BOMIFY-PDN: CHANGE THE FUSE RATING IN PDN.
AFTER SOME CURRENT MEASUREMENT IN PROTO UNITS.

SIZE	CLASS CODE	DWG. NO.	REV
B	BFU2	FPGA PG	
SCALE	DATE: Thu May 30 13:53:24 2024		70_QP 107

SIZE	CLASS CODE	DWG. NO.	REV
B			
SCALE	DATE: Thu May 30 13:53:23 2024		69-OP 107

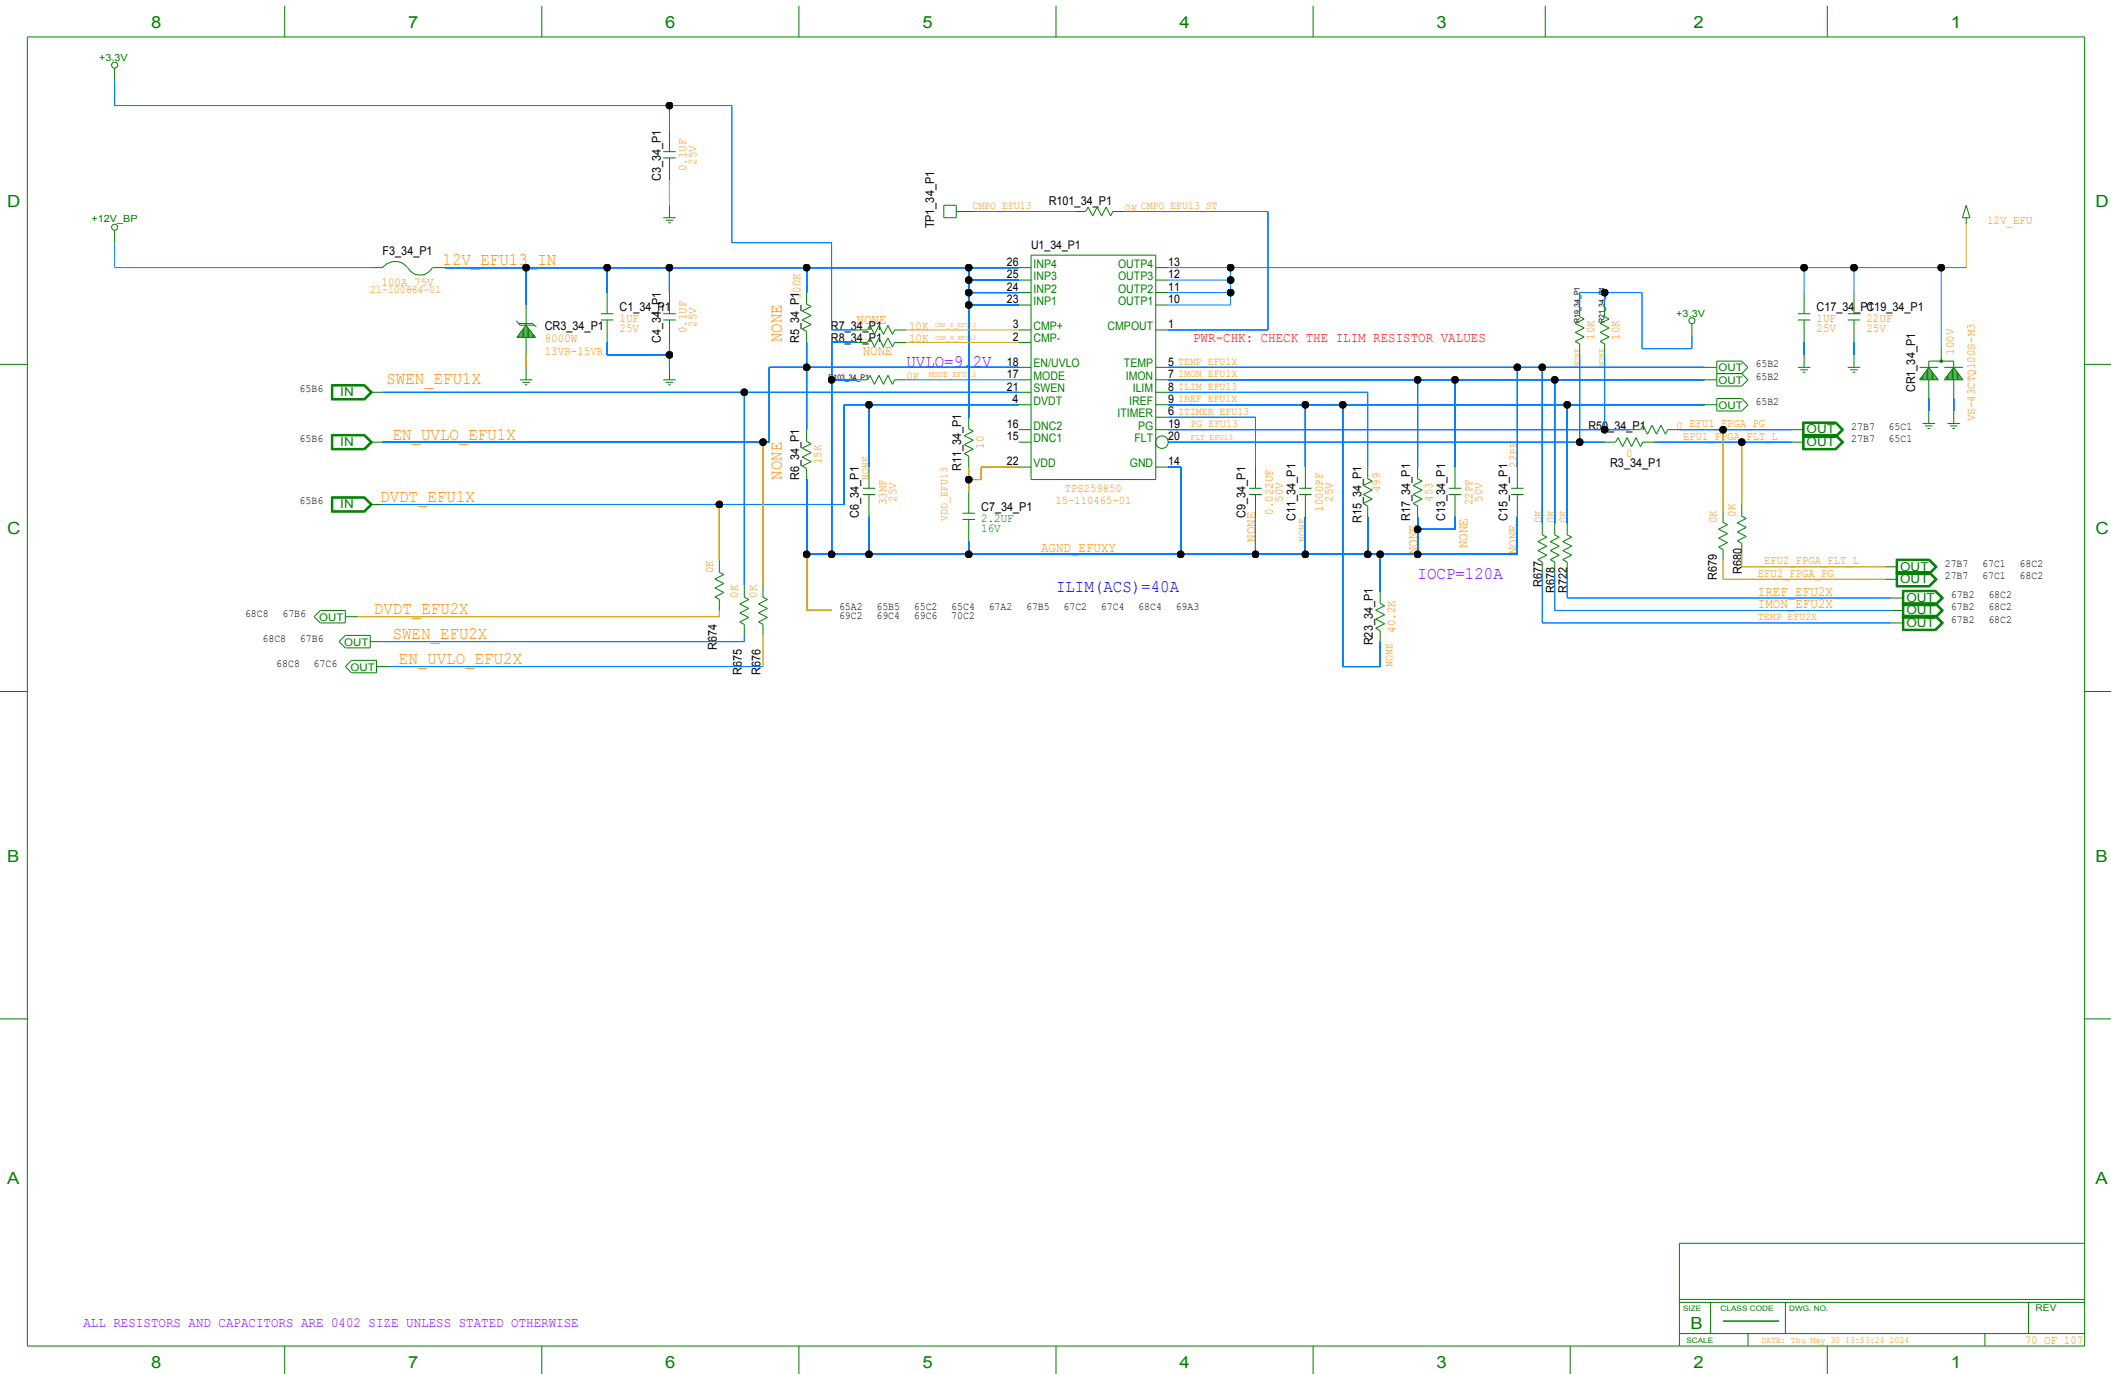
CHECK-PWR: USAGE OF CMP+/-

NOTE:BLEEDER RESISTOR
